UCC28180 input current spike

My customer is evaluating UCC28180-EVM573 now. Then they can see spike on the input current under following condition.

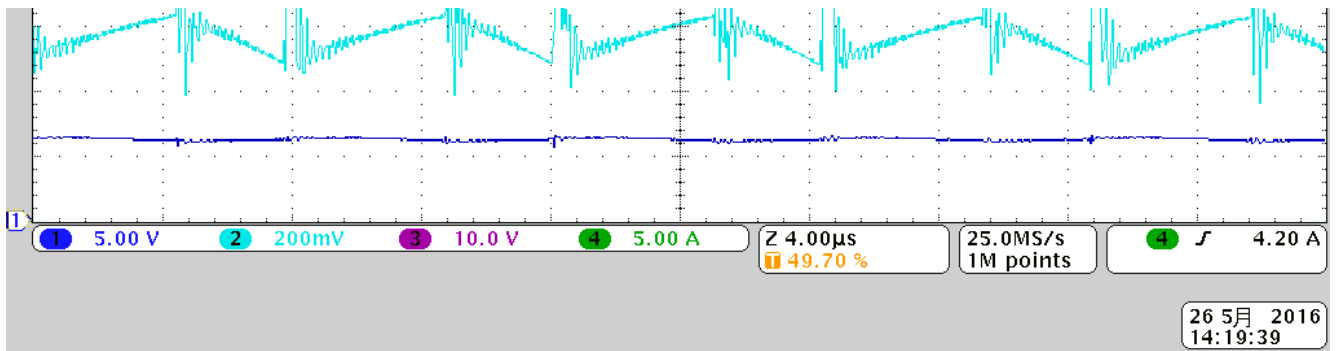
I just get more detail, however ICOMP voltage isn't clamped. Could you have any advice?

CH1: ICOMP

CH2: ISENSE

CH3: GATE

CH4: input current

The upper limit of ICOMP is about 6V, from your waveform ICOMP already hit the limit. Please reduce the value of current shunt resistor R4.
